**LICENSEE:** Exelon Generation Company, LLC (Exelon)  
**FACILITY:** Three Mile Island Nuclear Station, Unit 1  
**SUBJECT:** SUMMARY OF OCTOBER 20, 2009, MEETING WITH EXELON TO DISCUSS  
PROPOSED CONTROL ROD DRIVE CONTROL SYSTEM LICENSE  
AMENDMENT REQUEST (TAC NO. MD9762)

# EXELON PRESENTATION TO NRC REGARDING REACTOR TRIP BREAKER MODIFICATION

Figure 1-1. Block Diagram

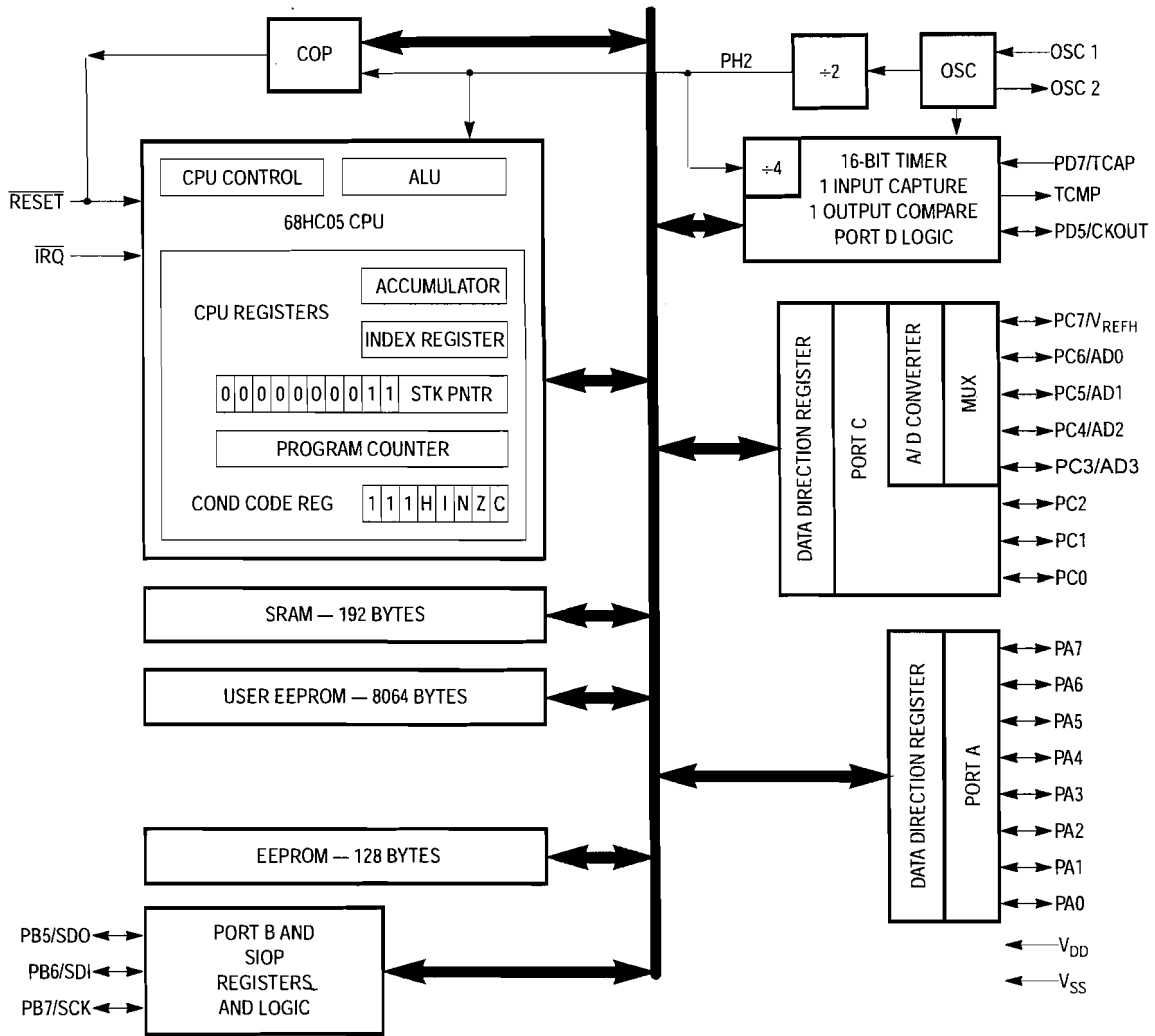
1. How complex is this microcontroller?
  - How many logical operations are going on?
  - What are these logical operations doing?

*A block diagram of the microcontroller is included as page 9 of presentation. The microcontroller is simple and consists of 8 modules. Details are presented in section 2.2.2.17.2 of the V&V report. The V&V report identifies the operation of the code.*
